HISTORIC AND DESIGN REVIEW COMMISSION

November 20, 2019

HDRC CASE NO: 2019-668
ADDRESS: 328 E HUISACHE AVE
LEGAL DESCRIPTION: NCB 3088 BLK 4 LOT 7 & E 25 FT OF 6
ZONING: MF-33,H
CITY COUNCIL DIST.: 1
DISTRICT: Monte Vista Historic District
APPLICANT: Sue Ann Pemberton/Mainstreet Architects Inc.
OWNER: Amy Scheinman/SCHEINMAN AMY L
TYPE OF WORK: Exterior modifications, porch modifications
APPLICATION RECEIVED: November 01, 2019
60-DAY REVIEW: December 31, 2019
CASE MANAGER: Stephanie Phillips
REQUEST:

1. Construct a new front porch.
2. Modify the existing front fenestration pattern.
3. Construct a new screened rear porch.

104 NORTH ELEVATION
SCALE: 1/4" = 1'-0"

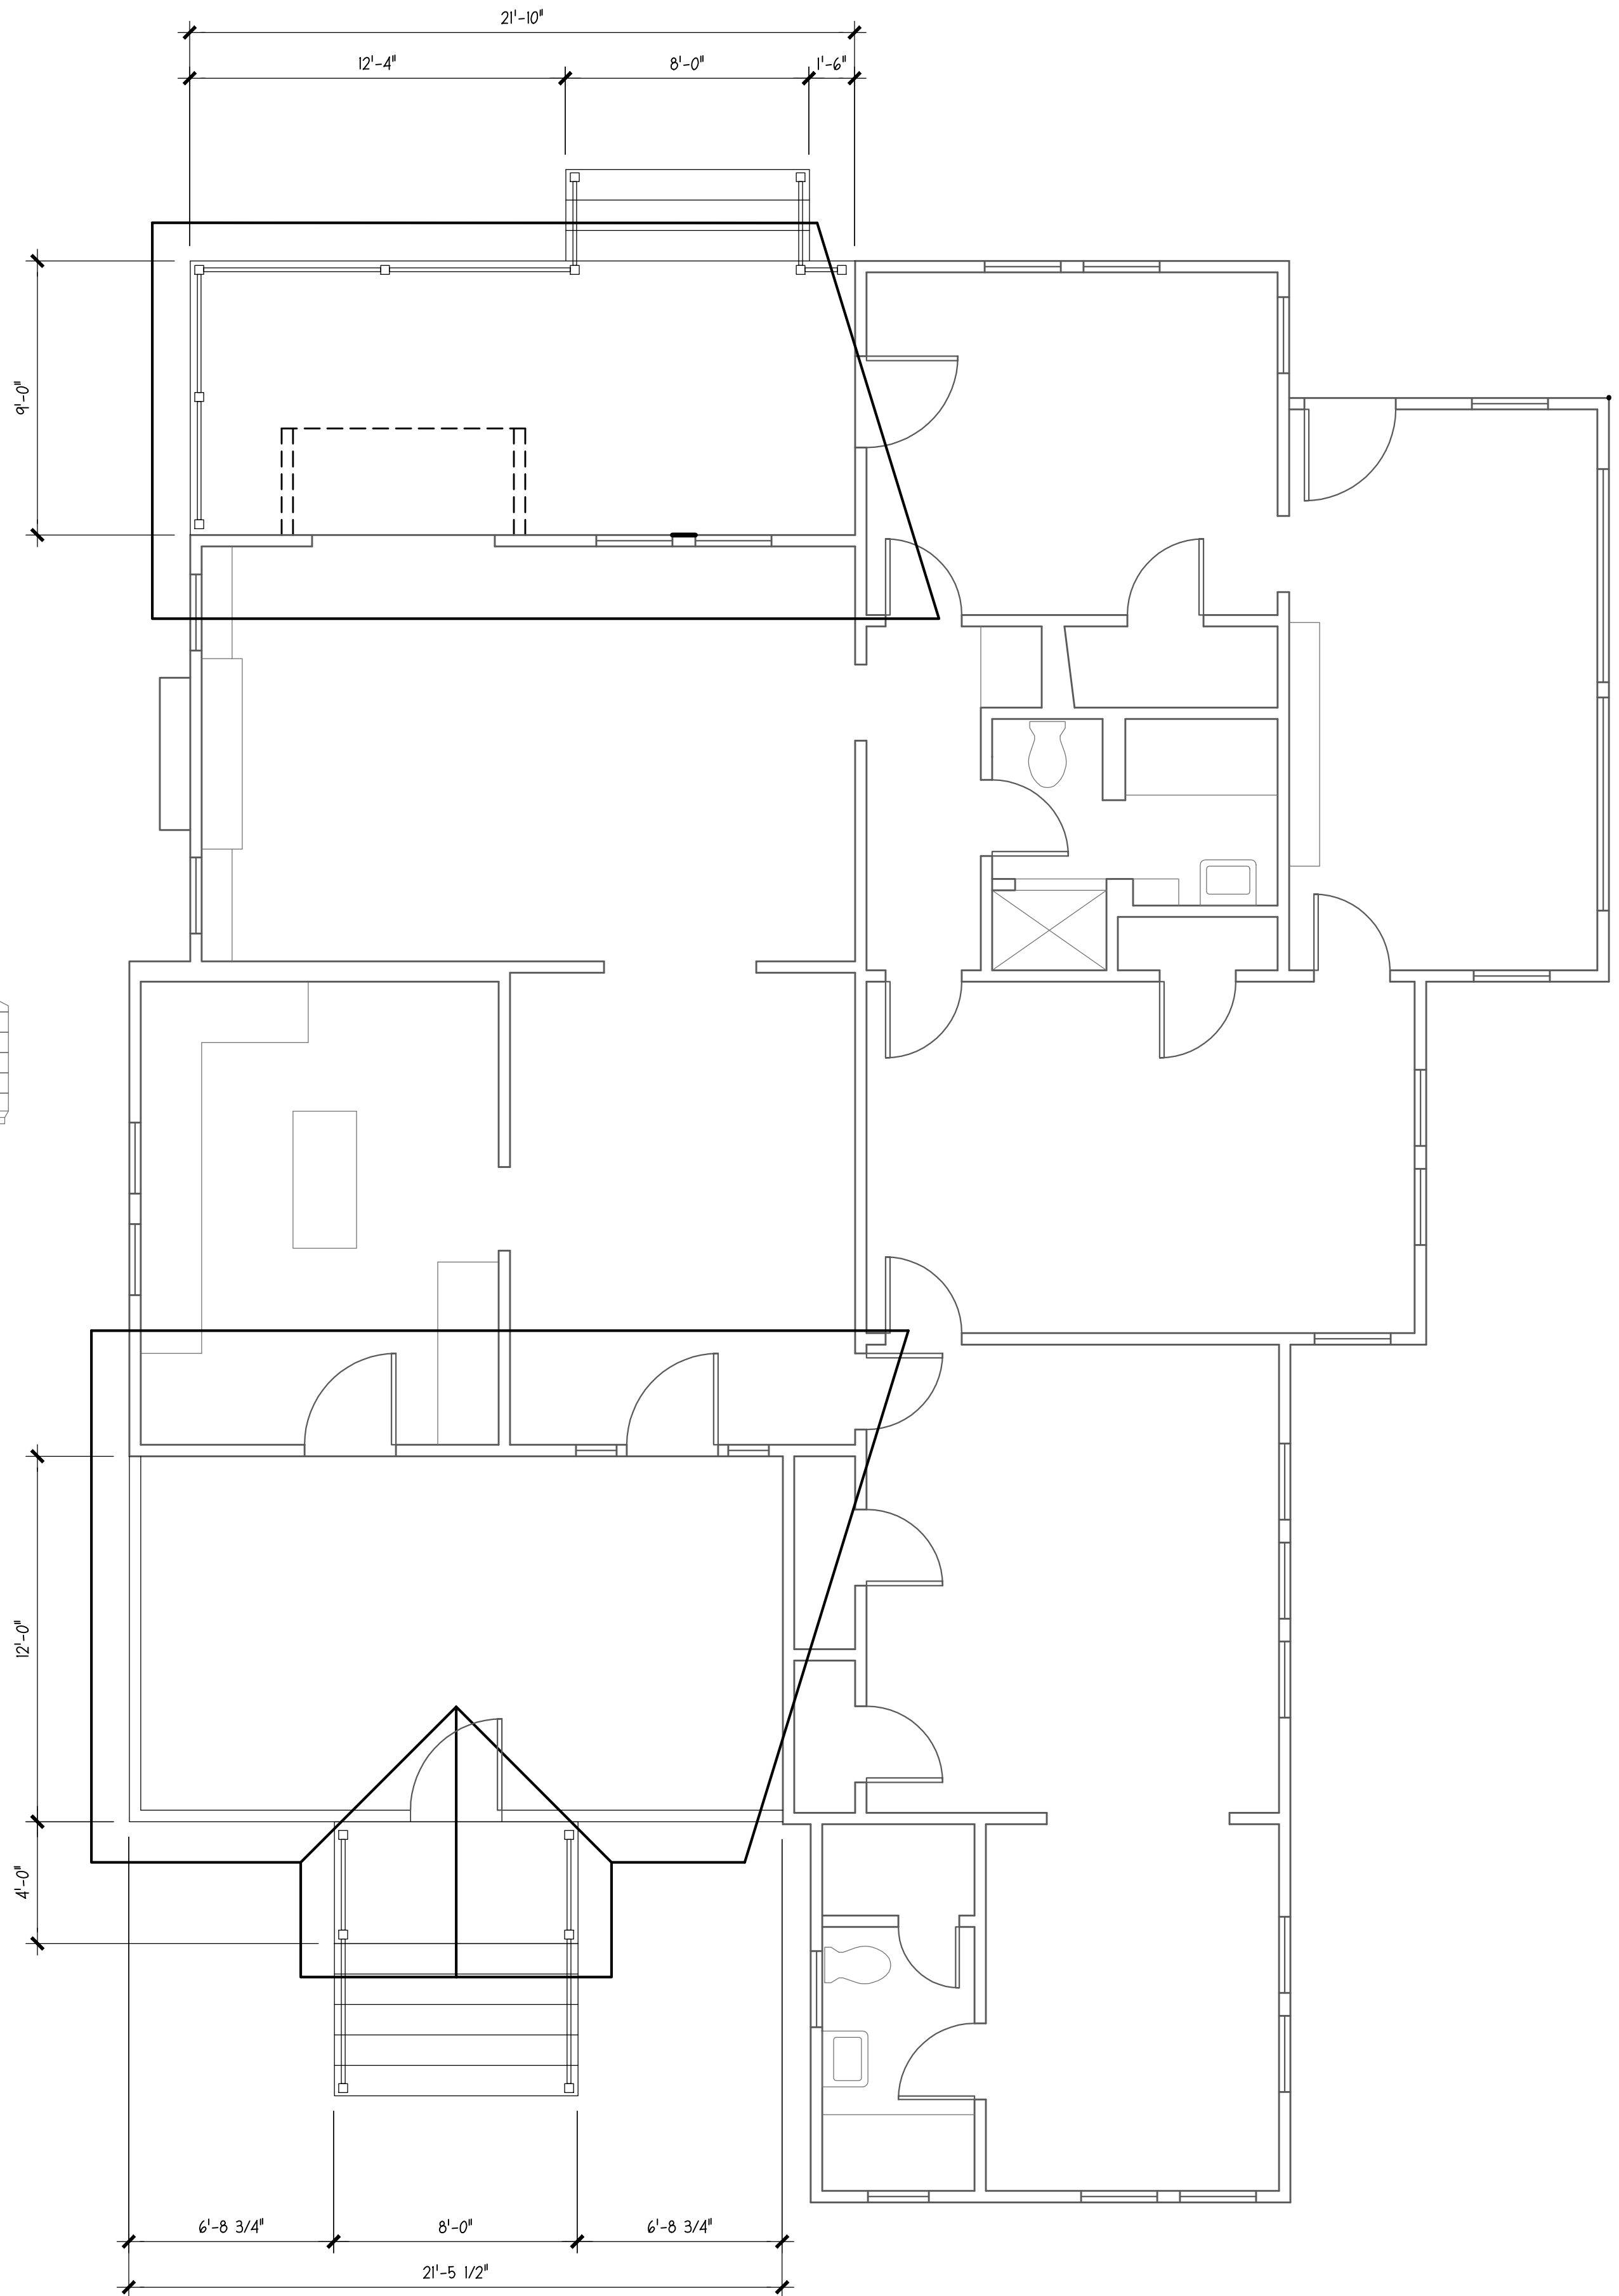
- b. FRONT PORCH – The applicant has proposed to construct a new front porch to the existing historic structure. The applicant has proposed a porch that will span the width of the inset portion of the front façade adjacent to the front gable. The porch will feature a low-sloping shed roof with simple wooden posts and railings and stairs that lead to the public right-of-way. The original entrance configuration, based on Sanborn Maps and remaining evidence, features a side-access front door located on the west side of the front gable. Based on the same evidence, the structure did not originally feature a front porch. According to the Historic Design Guidelines, porches and related entry elements should be restored to their original configuration. New elements should not detract from the original design of the structure or convey a false historic appearance. Staff does not find the proposed porch consistent with the Guidelines. Staff finds that the original entryway configuration should be retained and restored. Staff finds that a simple porch element emphasizing the existing original front entryway may be appropriate.

- c. FENESTRATION MODIFICATIONS – Per the submitted proposed elevation, the applicant has proposed to modify the front fenestration pattern. Two existing ganged windows will be relocated and swap locations with an existing non-original front addition. A new front door with side lites will be installed in the location of the existing ganged windows. As noted in finding b, the original front door of the structure is located on the west side of the front gable. The submitted existing and proposed elevation drawings do not indicate the intent for the original front door. The Guidelines state that existing fenestration configurations should be retained. Staff does not find the proposal consistent.

Item 1, Staff does not recommend approval of the construction of a new front porch based on finding b. Staff recommends that the applicant explore designs for a simple porch element emphasizing the existing original front entryway.

Item 2, Staff does not recommend approval of the fenestration modifications based on finding c. Staff recommends that the existing fenestration pattern, including the side front door, be retained and restored.

328 E HUISACHE AVENUE
PORCHES

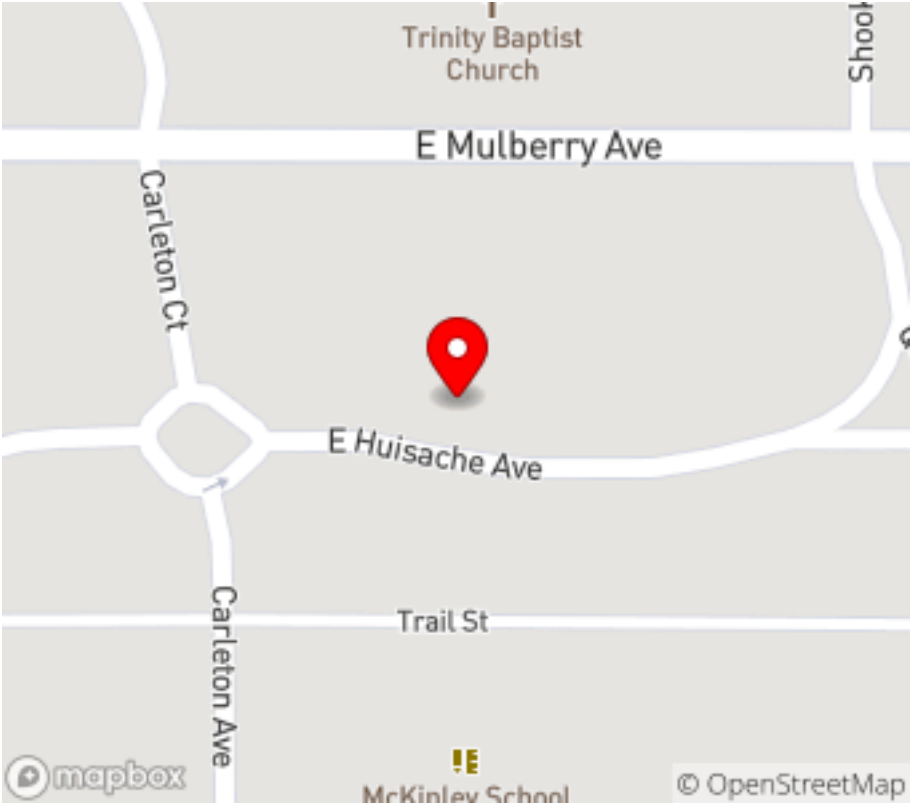
- d. REAR PORCH – The applicant has proposed to construct a new rear screened porch. The porch will measure approximately 250 square feet and will feature simple wood framing, transparent screens, and a new stairway with simple wooden posts and rails. The foundation will be clad in woodlap siding to match the existing structure and a vertical trim piece will be installed at the intersection of the two masses. According to the Historic Design Guidelines, new porch elements should be designed to be simple as to not distract from the historic character of the building. The porch will be simple in design and will not visually compete with the structure. Staff finds the proposal appropriate.

Item 3, Staff recommends approval of the rear screen porch based on finding d with the following stipulations:

- i. That the applicant submits all material specifications for the porch, including framing elements, screening, skirting, and railing for staff review and approval prior to receiving a Certificate of Appropriateness.
